# REPORT SUMMARY MINOR VARIANCE APPLICATION FILE NUMBER A090/24

### MINOR VARIANCE APPLICATION FILE NUMBER A090/24

CITY WARD #:	3
APPLICANT:	Mimi & Gordon Robertson
AGENT:	Melanie O'Sullivan (Terranova Pools)
PROPERTY:	88 Maria Antonia Road, Woodbridge
ZONING DESIGNATION:	See below.
VAUGHAN OFFICIAL PLAN	Vaughan Official Plan 2010 ('VOP 2010'): "Low-Rise Residential"
(2010) DESIGNATION:	
RELATED DEVELOPMENT	N/A
APPLICATIONS:	
PURPOSE OF APPLICATION:	Relief from the Zoning By-law is being requested to permit a proposed swimming pool and location of pool equipment.

#### Backyard Pool Design

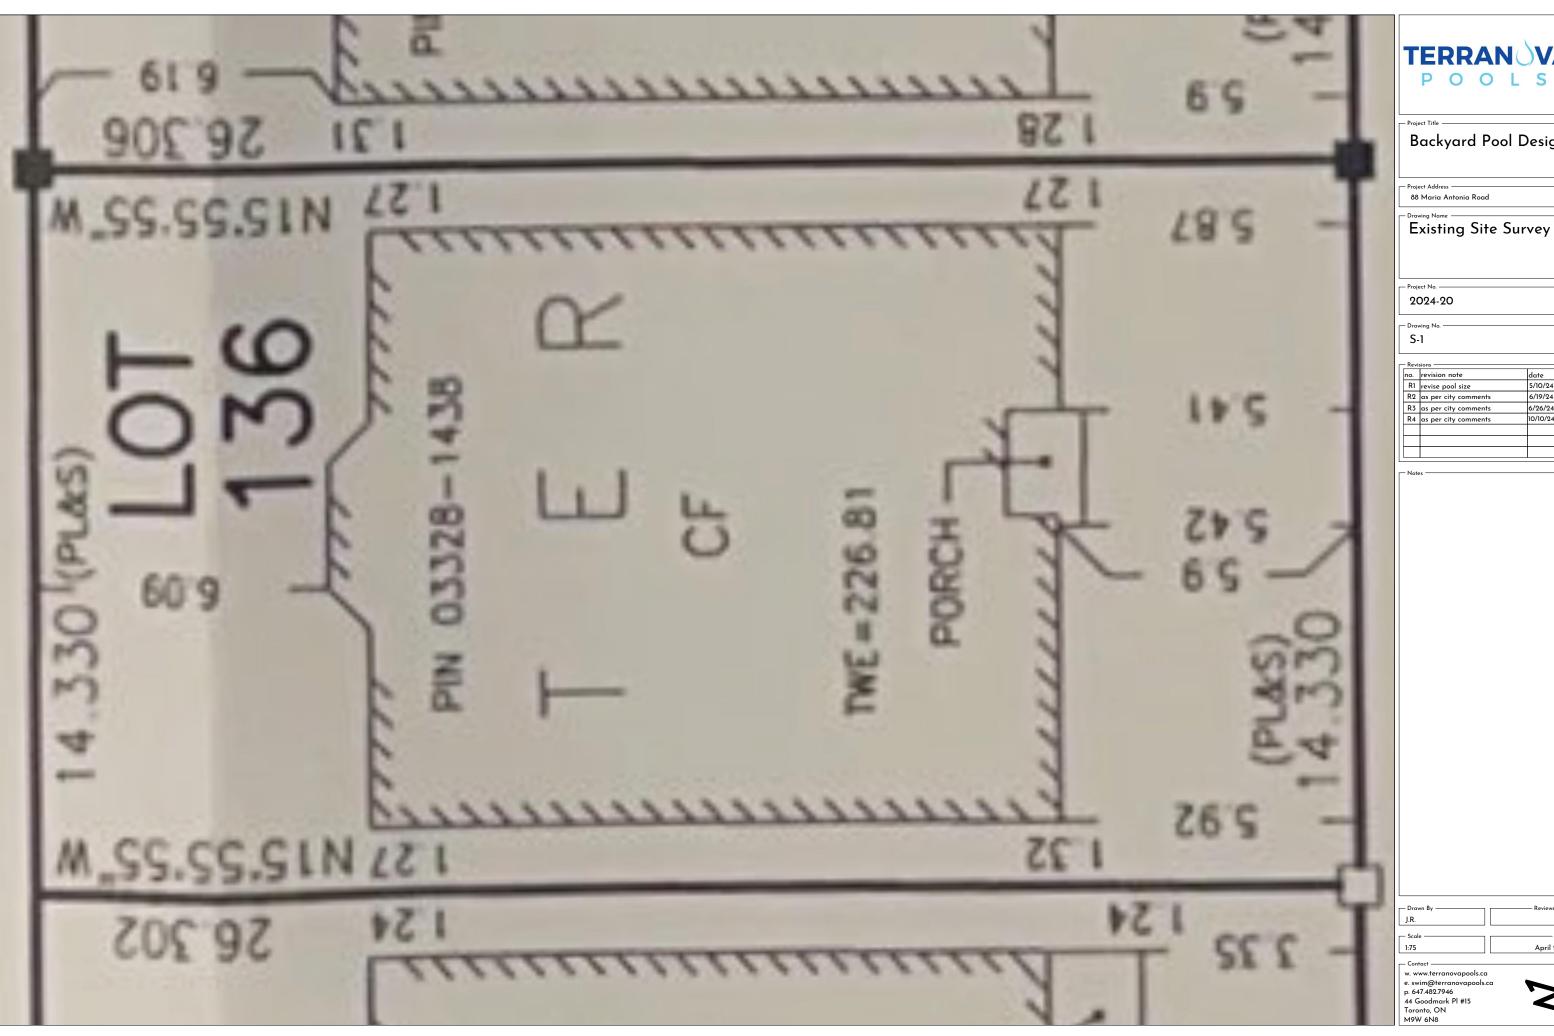
The Development Planning Department has no objections to Variances 1 and 2 for the proposed 0.91 m setbacks from the interior wall of the in-ground swimming pool to the rear and west interior lot lines respectively. The property has a wide and shallow rear yard When measured from the outer edge of the pool, the setbacks are approximately 0.6 m to both lot lines respectively. A planter bed is proposed for the 0.6 m space between the pool and the two lot lines, and will feature shrubs and ornamental grasses. The proposed pool is located 1.07 m from a staircase and landing area leading to the dwelling's rear wall. It would be difficult to relocate the pool in its current configuration closer toward the dwelling while maintaining sufficient space for access within the rear yard. The proposed reduced setbacks maintain sufficient spatial separation to accommodate access, maintenance, and soft landscaping. An existing 1.8 m tall wood privacy fence encircling the rear yard would mitigate negative use (privacy) and noise impacts that the pool may incur on the neighbouring properties to the west (92 Maria Antonia Road), north (33 Jordan Hofer Way), and northwest (37 Jordan Hofer Way). As such, the Development Planning Department is of the opinion that the setback variances requested for the in-ground pool are minor in nature and desirable for the development of the land.

The Development Planning Department has no objections to Variances 3 and 4 for the increased rear yard encroachment and reduced east interior side yard setback for the pool equipment pad. The pool equipment pad is proposed in the northeast corner of the rear yard with a 0.31 m setback from the rear and west interior side lot lines respectively. The pad is approximately 2.6 m² in area and consists of a heater, a pump, and a filter. The maximum height of the equipment is 0.83 m. The existing 1.8-m tall privacy fence is anticipated to buffer the pool equipment from the neighbouring properties to the east (84 Maria Antonia Road), north (33 Jordan Hofer Way), and northeast (27 Jordan Hofer Way). The 0.31 m setbacks maintain sufficient space for maintenance access.
